SPARC® Enterprise M4000/M5000 Servers Product Notes

For XCP Version 1081

FIGURE 8-6 Sequence of Fixing the PCI Card in Position

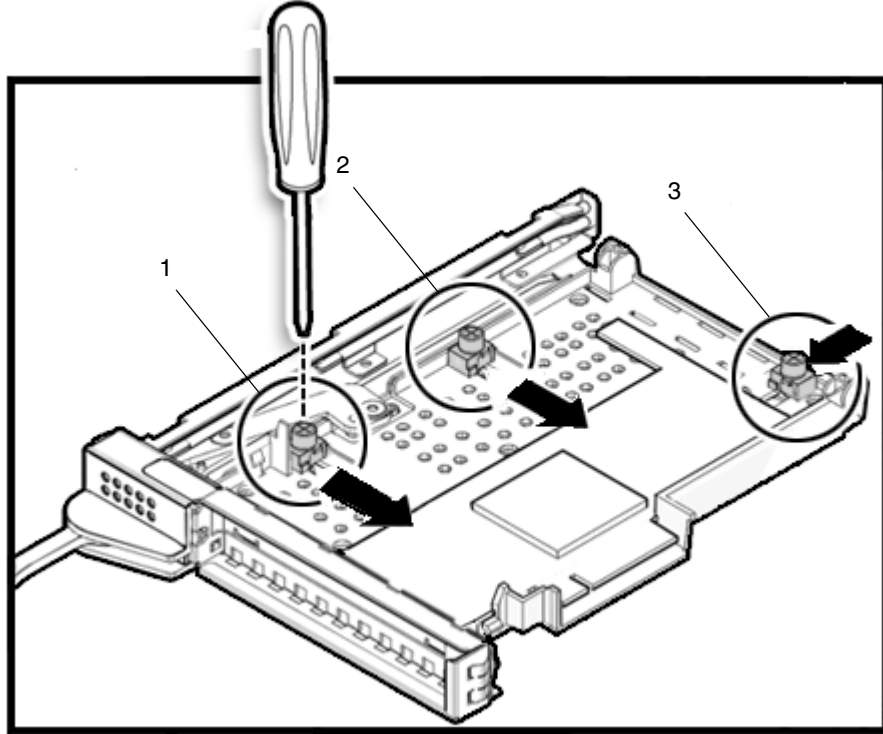
This is to correct step 4 in Section 8.2.2, "Installing the PCI Card" on page 8-9.

4. **Slide the adjustable stops into position against the PCI card to hold it in place and secure them with a screwdriver.**

Note – The adjustable stops should be snug against the card and securely tightened to ensure the card seats correctly. Also, fix the PCI card in position by following the 1-2-3 sequence in FIGURE 8-6.
